# Access Compliance Report

## Public Rights-of-Way

Intersection ID: 23217	Main Street: GLENEAGLES_RD	Cross Street: QUAIL_HOLLOW_RD	Location: SW
ADA ID: AE2C6524D033	Ramp Type: PerpDiag	Initial Pass/Fail: Fail	Overall Compliance: No
		Severity Score: 26.25

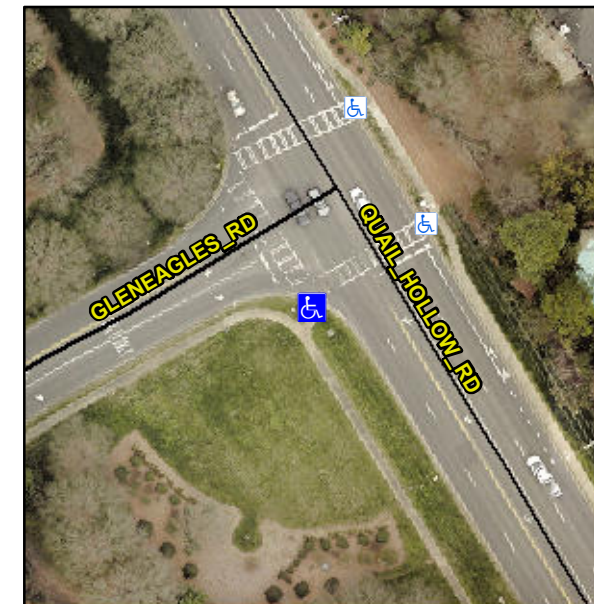
**R304.2.2, R304.5.3**

Compliance	Description	Data	Compliance	Description	Data
N/A	Ramp Length (in)	45.0	No	Ramp Slope (%)	12.3
Yes	Ramp Width (in)	48.0	No	Ramp XSlope (%)	2.6
N/A	Flare Type LT	N/A	N/A	Flare Type RT	N/A
N/A	Flare Slope LT (%)	N/A	N/A	Flare Slope RT (%)	N/A
N/A	Flare Traversable LT?	N/A	N/A	Flare Traversable RT?	N/A
N/A	Landing Length (in)	N/A	N/A	DWS Provided?	N/A
N/A	Landing Width (in)	N/A	N/A	DWS Contrast?	N/A
N/A	Landing Slope (%)	N/A	N/A	DWS Length (in)	N/A
N/A	Landing X Slope (%)	N/A	N/A	DWS Full Width?	N/A
N/A	Landing Curb? (Y/N)	N/A	N/A	DWS Offset (in)	N/A
N/A	Shared Landing?	N/A			
N/A	Gutter Ponding?	N/A	N/A	Gutter Slope (%)	N/A
N/A	Gutter Lip Ht (in)	N/A	N/A	Gutter X Slope (%)	N/A
N/A	Painted X Walk1?	Yes	N/A	Painted X Walk2?	Yes
	X Walk 1 Direction	To E		X Walk 2 Direction	To N
N/A	X Walk 1 Width (in)	109.0	N/A	X Walk 2 Width (in)	112.0
	X Walk 1 Slope (%)	2.1		X Walk 2 Slope (%)	2.1
	X Walk 1 X Slope (%)	3.3		X Walk 2 X Slope (%)	2.3

**Remove & Replace Curb Ramp With Two New Directional Ramps or Equivalent.**
